UNLESS OTHERWISE SPECIFIED, DIMENSIONS ARE IN INCHES		CONTRACT NO.	
TOLERANCES ARE:		APPROVALS	
DECIMALS	FRACTIONS	DATE	
±.005	±.005	5/14/94	
DO NOT SCALE DRAWING		CHECKED	
DRAWN		DATE	
5/14/94			
ENG.		SCALE	
APPROD		RELEASE DATE	
10-0108-5900		SHEET 1 OF 1

CROSSOVER,
LS FX SURROUND

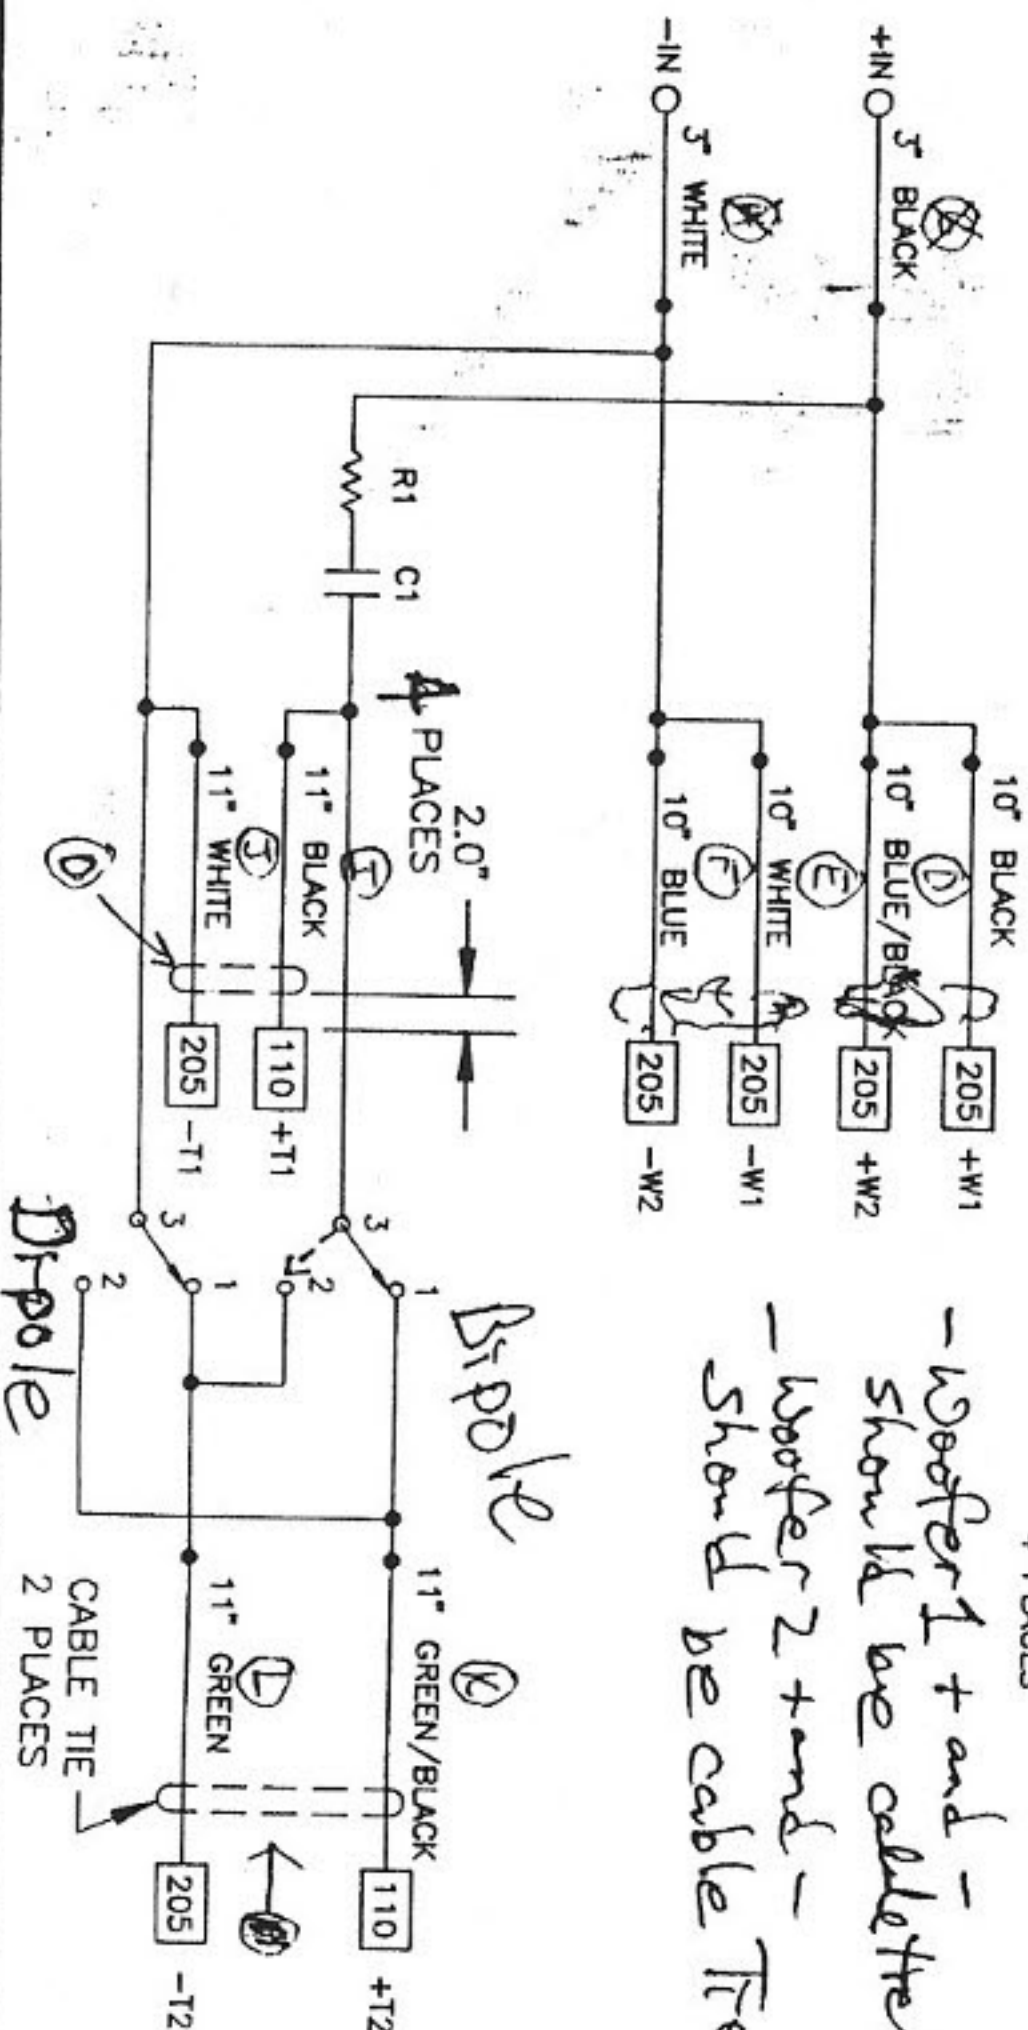
-Woofer 1 + and -
should be deleted
-Woofer 2 + and -
should be cable tied
